Staff Report

PLANNING DIVISION
COMMUNITY & NEIGHBORHOOD DEVELOPMENT

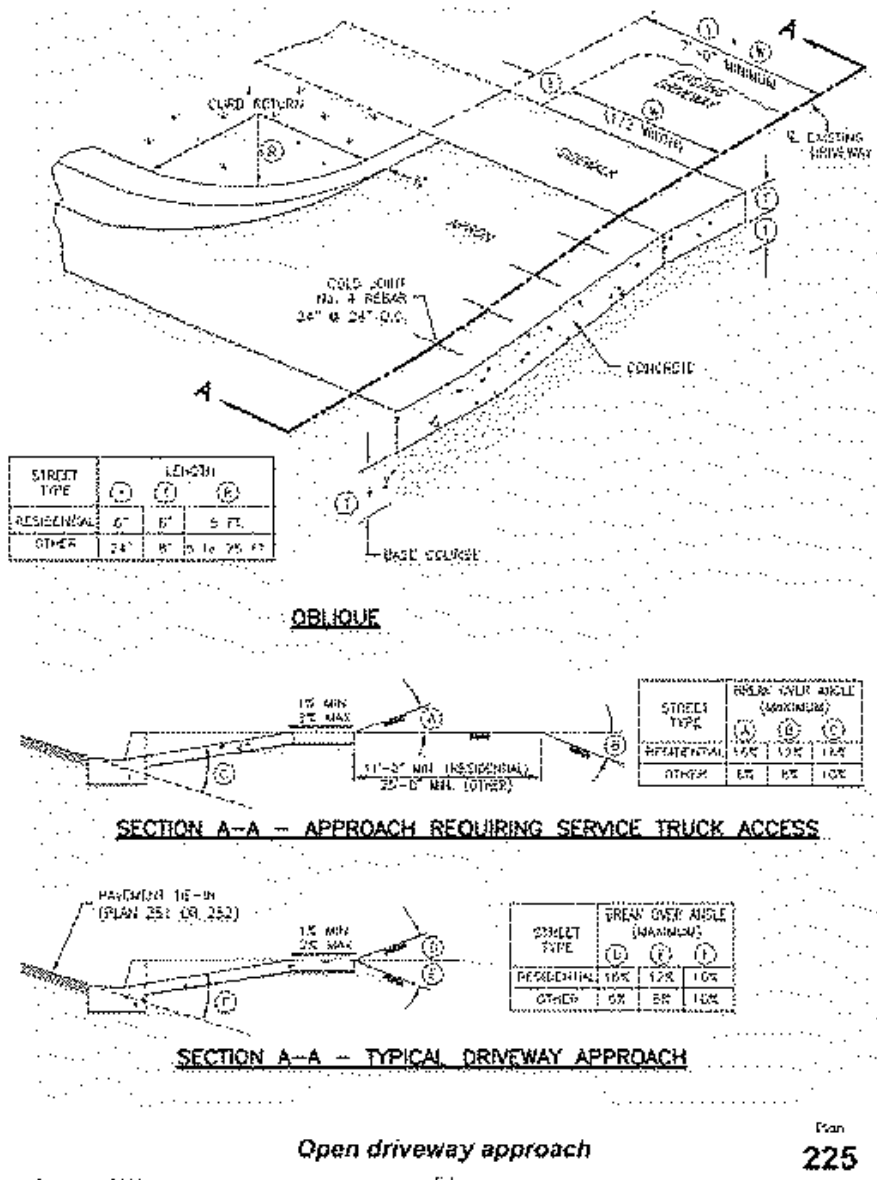
B. Field Changes to Slope Requirements:
Grades may have a 6 percent change in slope over a 11 feet wheel base run for both crest or sag vertical curves.
Where heavy truck use and fire truck access applies, or to improve design speed, design grades should be cut in half.
Specific uses or site conditions may require profile design submitted for review and acceptance.
